Standards Subcommittee

March 26 2025, Denver, CO.

L.3.1 Standards Working Group on the Continuous Revision of C57.12.00

Standards Working Group on the Continuous Revision of C57.12.90

Figure 2 —Induced-voltage test for Class II power transformers

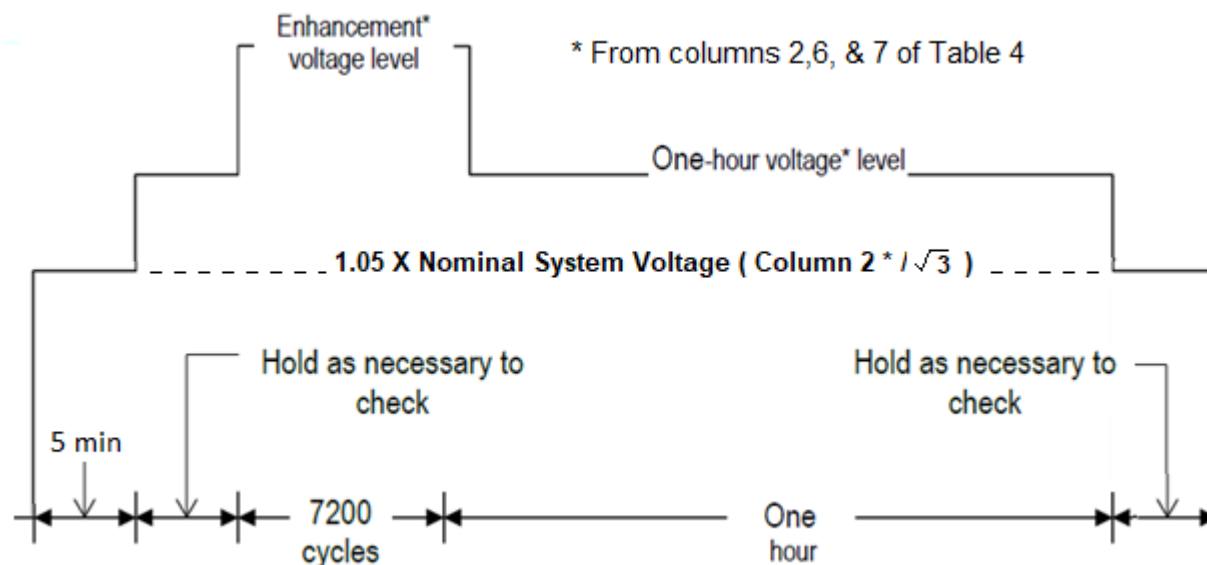
1. Changes to Low Frequency Tests from Ajith Varghese's RLFT TF in the Dielectric Test SC. The final survey approved by TF and SC in the Spring 2023 meeting is shown below. Text in black is existing, red is revised, blue is added.

With the transformer connected and excited as it will be in service, an induced-voltage test shall be performed as indicated in Figure 2, at voltage levels indicated in Columns 6 and 7 and **1.05 times the line to ground voltage per column 2 of Table 4**. Minimum line-to-ground induced test levels for Class II power transformers shall be a multiple of corresponding line-to-ground nominal system voltage as follows: 1.58 times for one-hour tests and 1.8 times for 7200 cycles enhancement level tests.

5.7.2 Angular displacement (nominal) between voltages of windings for three-phase transformers

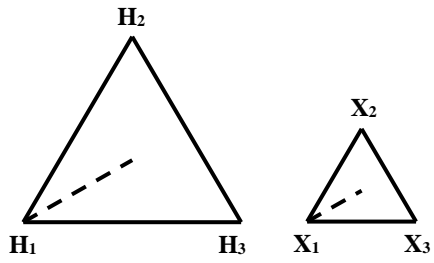
- Three motions passed:
 - Motion #1: Add the following sentence at the end of the second paragraph in Subclause 5.7.2: "The phasor group designation (vector group) shall be shown on the transformer's nameplate, near the phasor diagram."

Unless specified otherwise and identified on the nameplate, the angular displacement between high-voltage and low-voltage phase voltages of three-phase transformers with Δ-Δ or Y-Y connections shall be zero degrees. The phasor group designation (vector group) shall be shown on the transformer's nameplate, near the phasor diagram.

Figure 1 —Phase relation of terminal designation for three-phase transformers

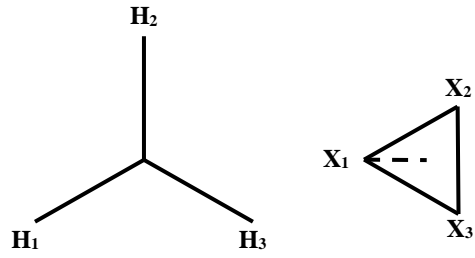
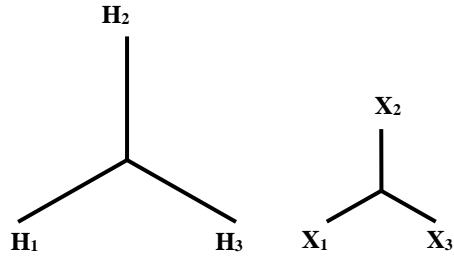
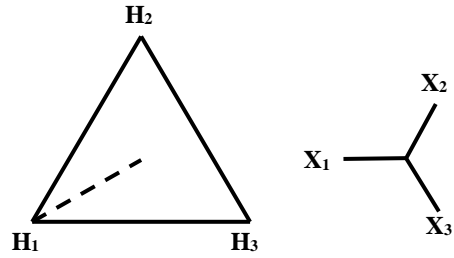
- Motion #2: Revise existing Figure 1 to describe the phasor group designation for the four example connections given, as: Dd0, Yd1, Yy0, Dy1
 - Motion #3: Revise Table 6, Row 11 for Nameplates A, B, and C. Change "Phasor Diagram" to "Phasor Diagram and Phasor Group Designation"

$\Delta - \Delta$ CONNECTION (Dd0)

$Y - \Delta$ CONNECTION (Yd1)

Figure 2—Induced-voltage test for Class II power transformers

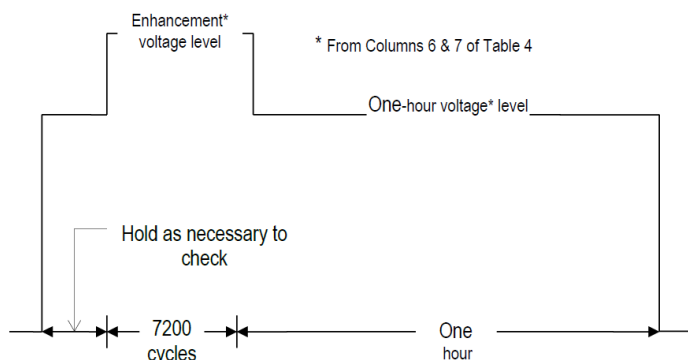
4. Changes to Low Frequency Tests from Ajith Varghese's RLFT TF in the Dielectric Test SC. The final survey approved by TF and SC in the Fall 2024 meeting is shown below. Text in black is existing, red is revised, blue is added.

With the transformer connected and excited as it will be in service, an induced-voltage test shall be performed as indicated in Figure 2, at voltage levels indicated in Columns 6 and 7 of Table 4. ~~Minimum line-to-ground induced test levels for Class II power transformers shall be a multiple of corresponding line-to-ground nominal system voltage as follows: 1.58 times for one-hour tests and 1.8 times for 7200 cycles enhancement level tests.~~
